**CITY OF AUSTIN
APPLICATION TO BOARD OF ADJUSTMENT
GENERAL VARIANCE/PARKING VARIANCE**

STREET ADDRESS: 5300, 5304, 5400 North Lamar Boulevard Austin, Texas 78751

**E-6 C15-2011-0106 Michele Rogerson Lynch for Todd Triggs
 5400 North Lamar**

A-1

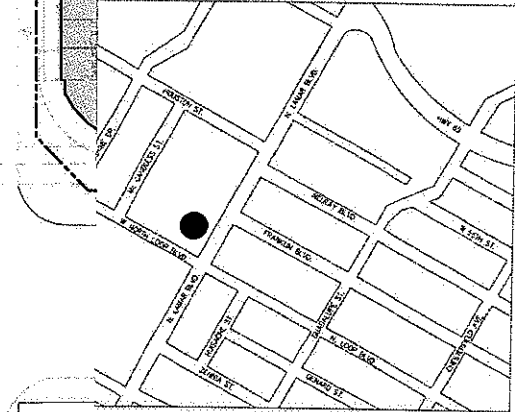
I don't see a problem with the set back change as long as you provide proper clearances from the duct bank to be installed (5' min from any permanent structure) and provide the appropriate clearances for the transformer locations (5' on all non operating sides and 10' on operating sides.) Just make sure that the retaining wall isn't located in any Electric Utility Easement or PUE and we should be good. The truck access that is required to our transformers is 20' horizontal width and 35' vertical clearance. Any further questions feel free to call or email.

I have received a board of adjustment review request for the above referenced property requesting to reduce the 25 ft compatibility setback to 10 feet in order to erect a retaining wall. I have marked the proposed retaining wall in red on the attached plan, can you please take a look at it and let me know if this retaining wall is in conflict with your proposed design to serve this development. If possible, can you send me a response by this Thursday because I have to turn in my comments to the Board of Adjustments before Monday's meeting? Thank you,

OPENING WALL REQUESTING VARIANCE FROM 25-2-1063(B)(2)
 ALLOWED SETBACK: 25'-0"
 PROPOSED SETBACK: 10'-0"
 VARIANCE REQUEST: 15'-0"

APPROVED BY AUSTIN ENERGY provided any existing or future improvements meet AE clearance criteria requirements as well as be in compliance with the National Electric Safety Code and OSHA. Required clearances from the duct bank to be installed - 5' min from any permanent structure; clearances for the transformer locations - 5' on all non operating sides and 10' on operating sides. The proposed retaining wall cannot be located in any Electric Utility Easement or PUE. The truck access that is required to our transformers is 20' horizontal width and 35' vertical clearance. If you have any questions, please call Chad Leingang at 505-7116.
